277-289 WOODPARK ROAD SMITHFIELD NSW 2164

CIVIL WORKS

AMENDED PLAN

ALS
SMITHFIELD REDEVELOPMENT APPLICATION
277-289 WOODPARK ROAD SMITHFIELD LOT 1 IN DP1024505
COVER SHEET, DRAWING LIST
AND LOCALITY PLAN
CALIBRE DRG No.
COPP20170-DWG-C-0000
CLIENT DRG No.

ALS
SMITHFIELD REDEVELOPMENT APPLICATION
277-289 WOODPARK ROAD SMITHFIELD LOT 1 IN DP1024505
GENERAL ARRANGEMENT PLAN
SHEET 3 OF 4

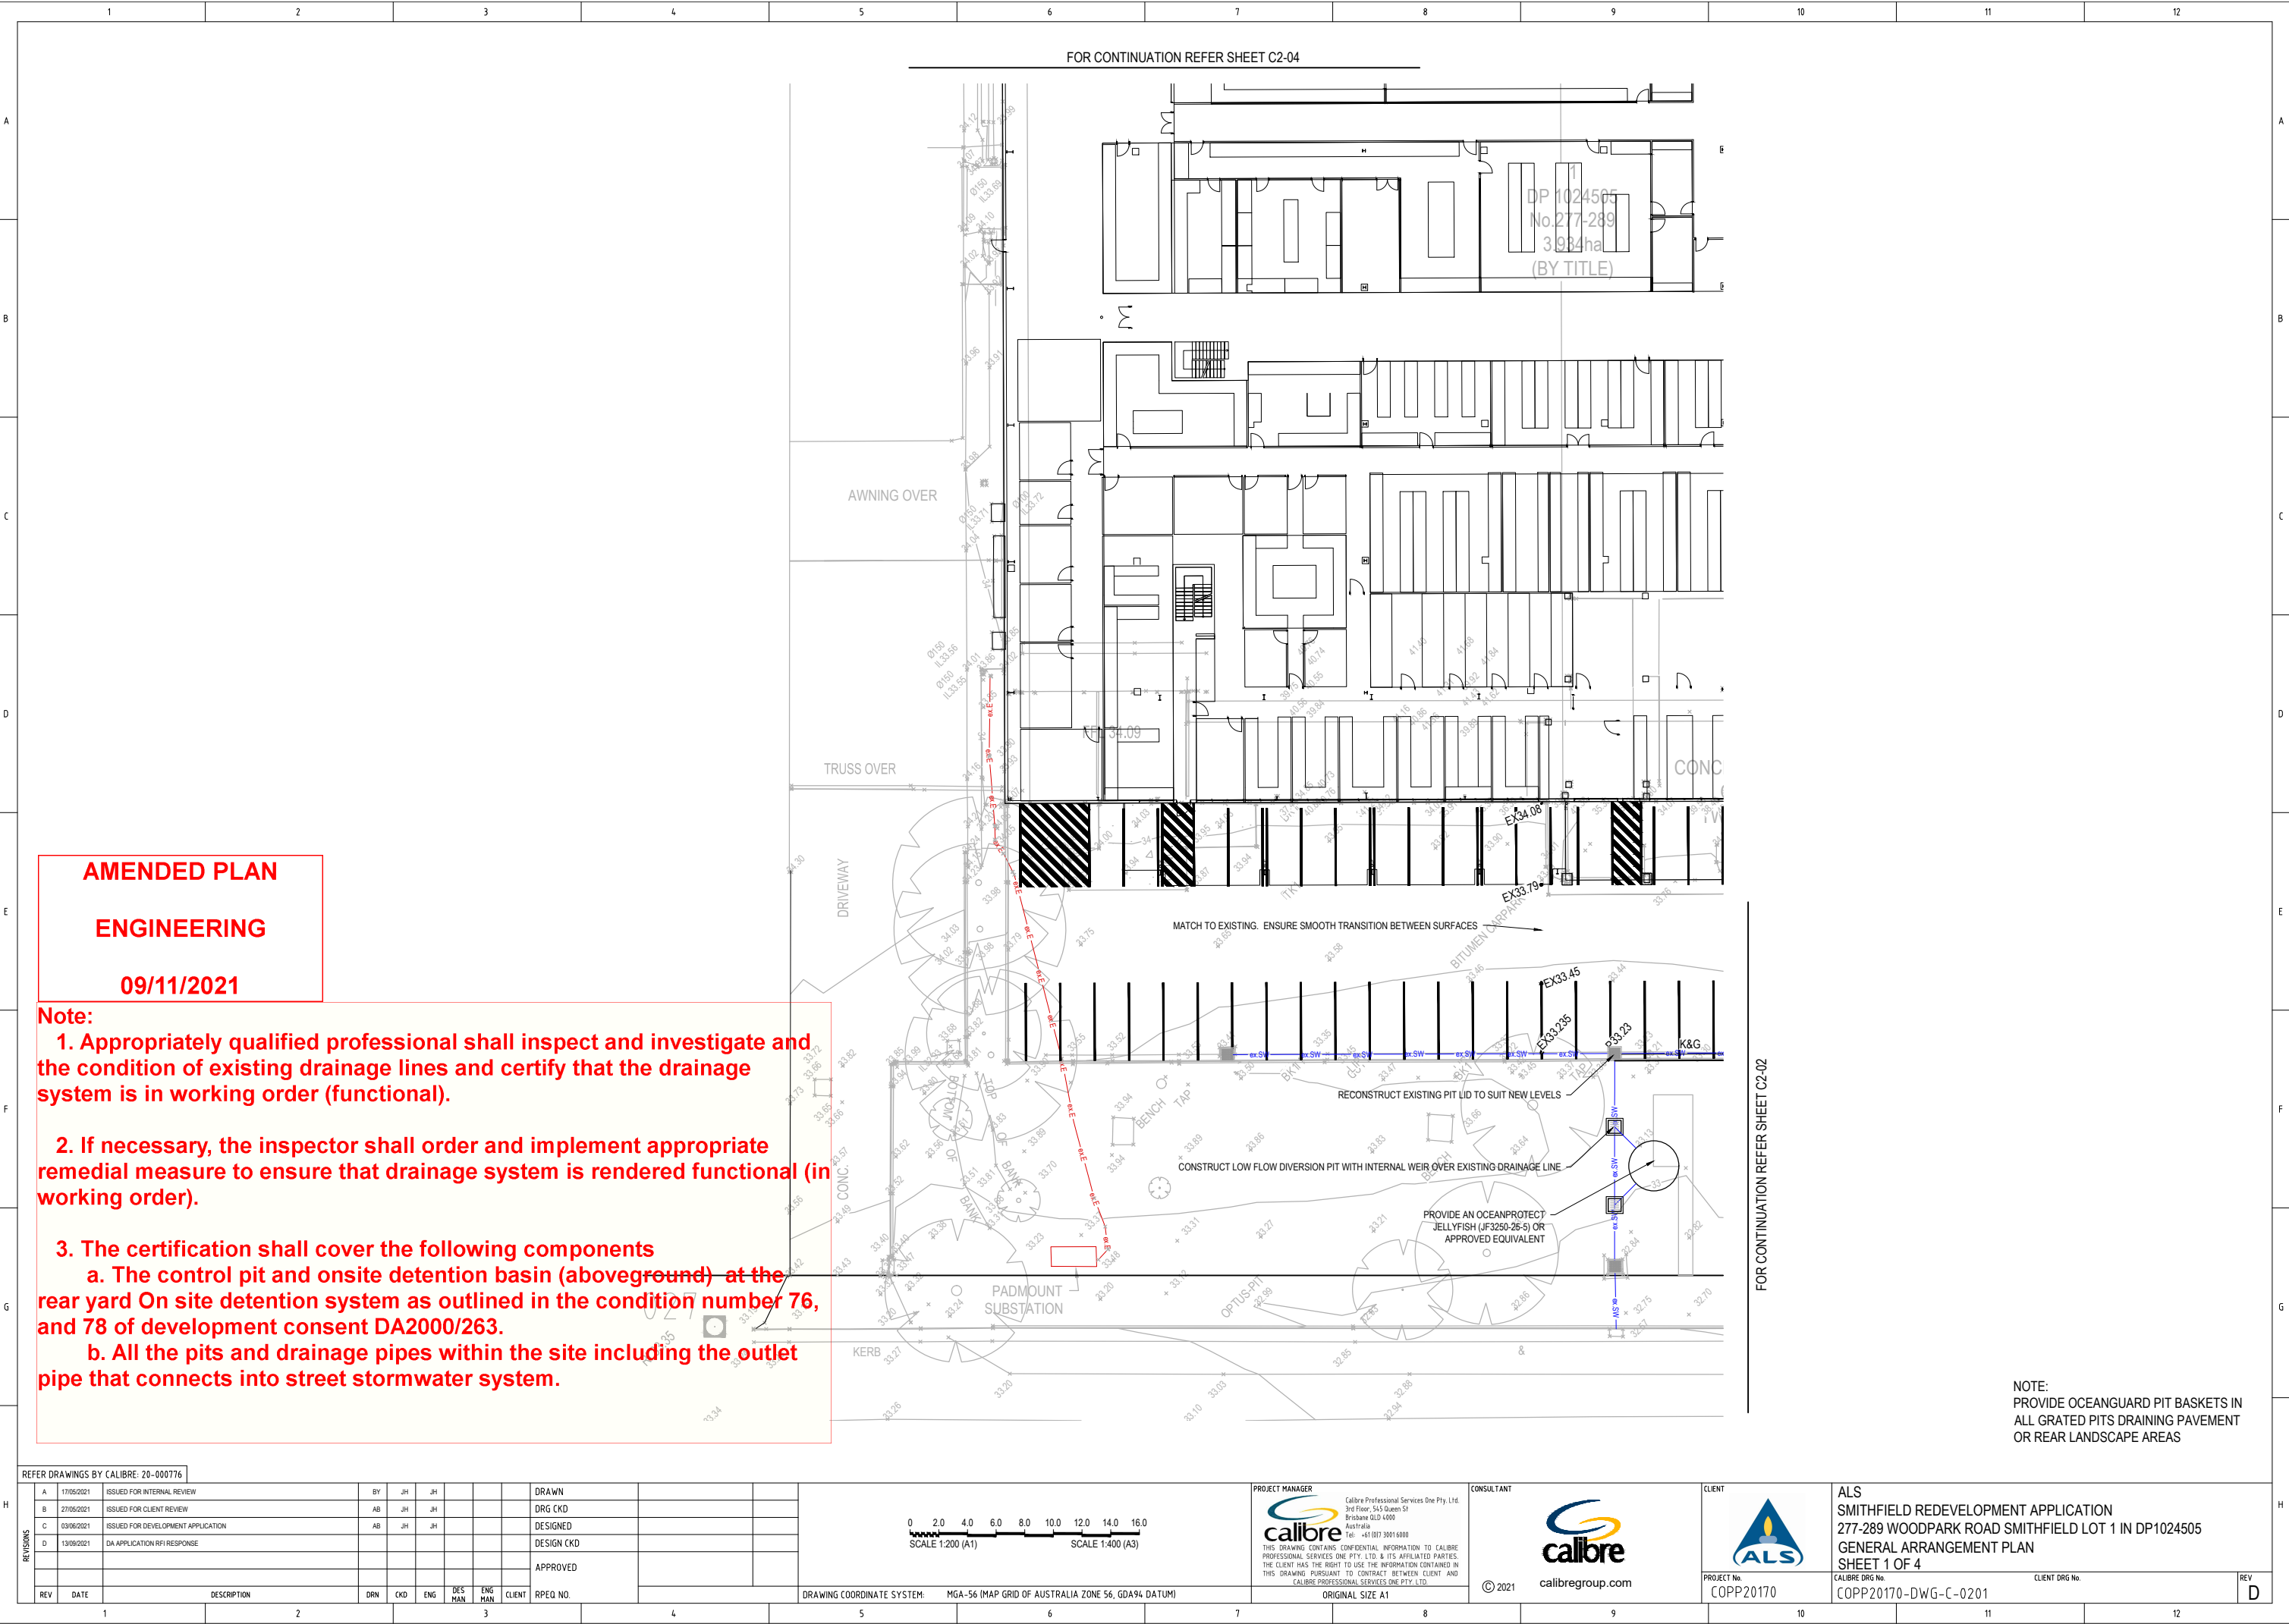
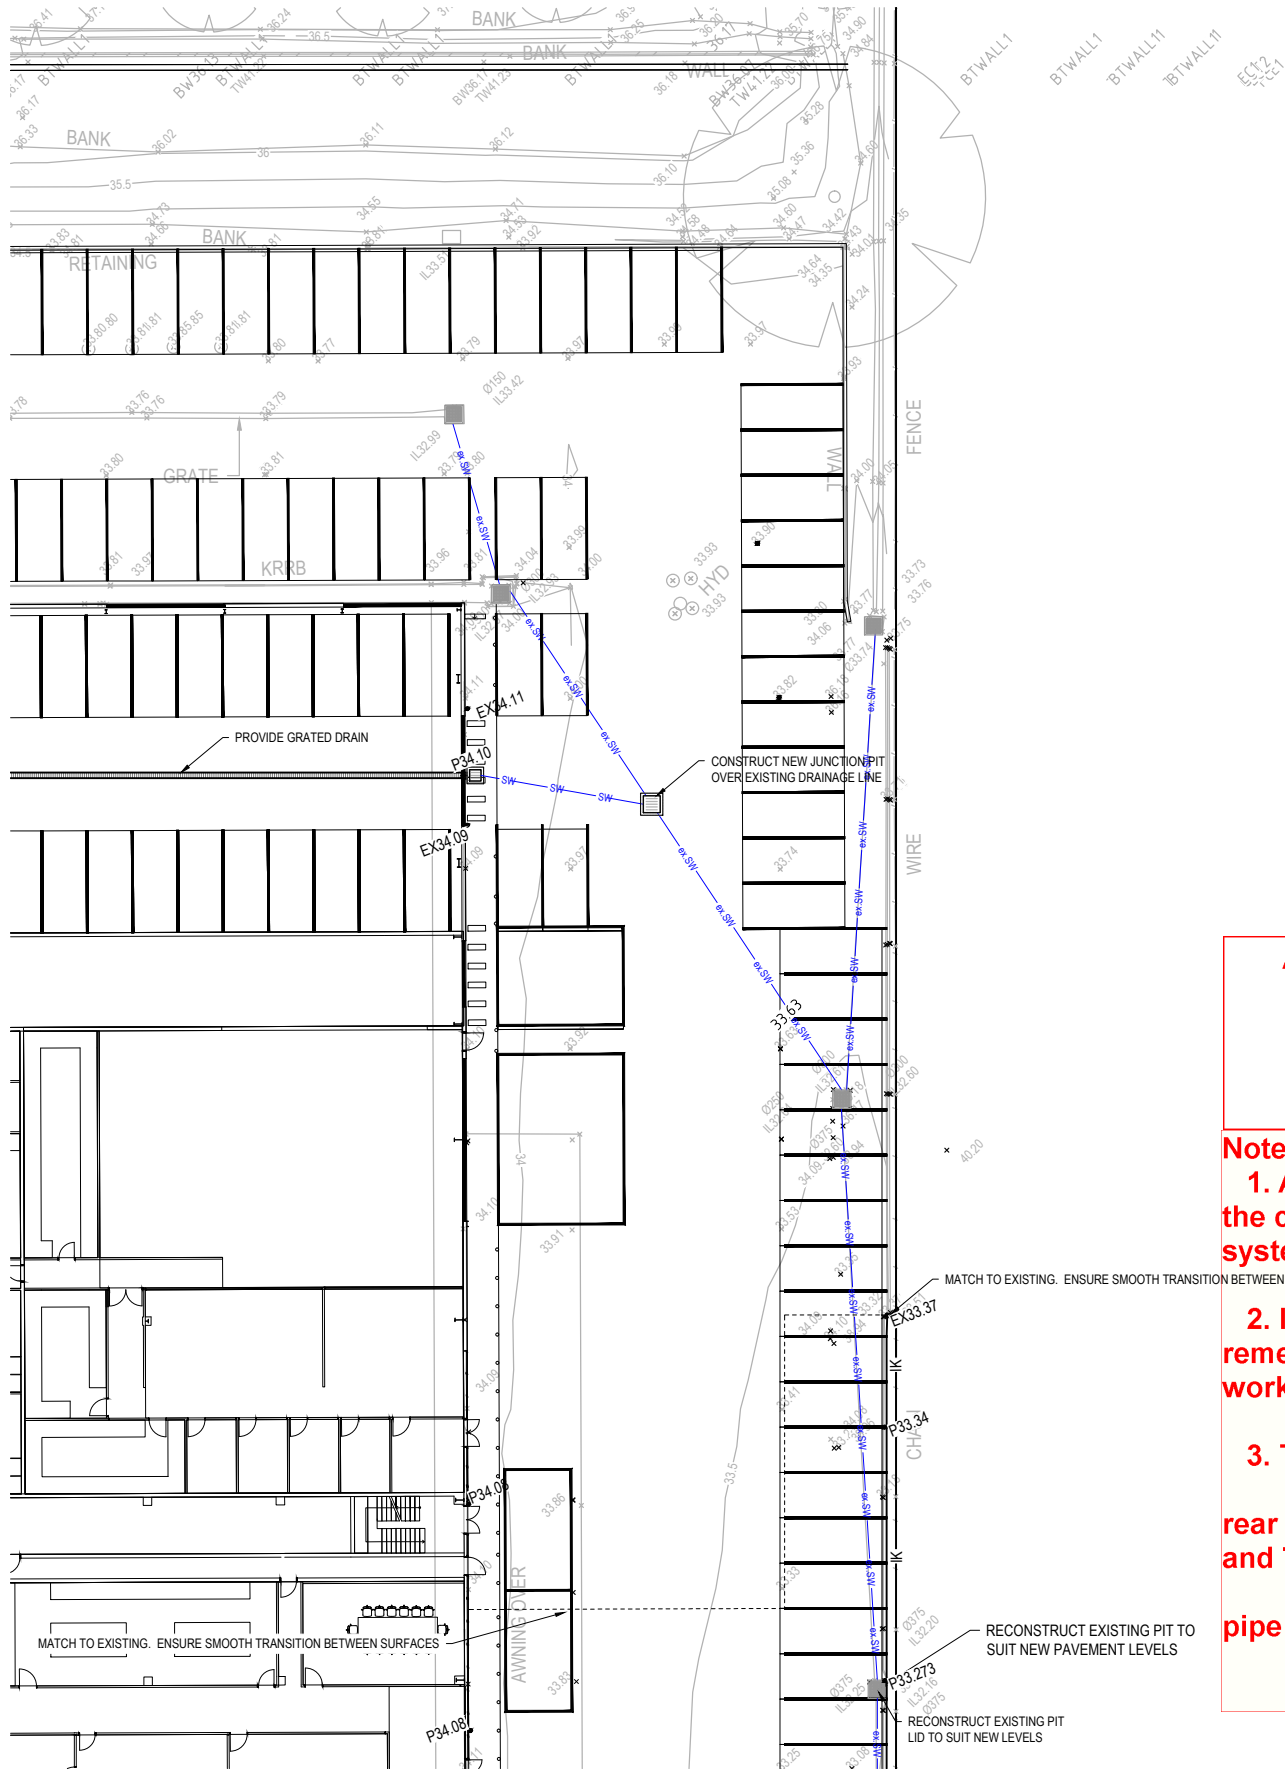
1. Appropriately qualified professional shall inspect and investigate and the condition of existing drainage lines and certify that the drainage system is in working order (functional).

3. The certification shall cover the following components

a. The control pit and onsite detention basin (aboveground) at the rear yard On site detention system as outlined in the condition number 76, and 78 of development consent DA2000/263.

NOTE:
1. PROVIDE OCEANGUARD PIT BASKETS IN ALL GRATED PITS DRAINING PAVEMENT OR REAR LANDSCAPE AREAS
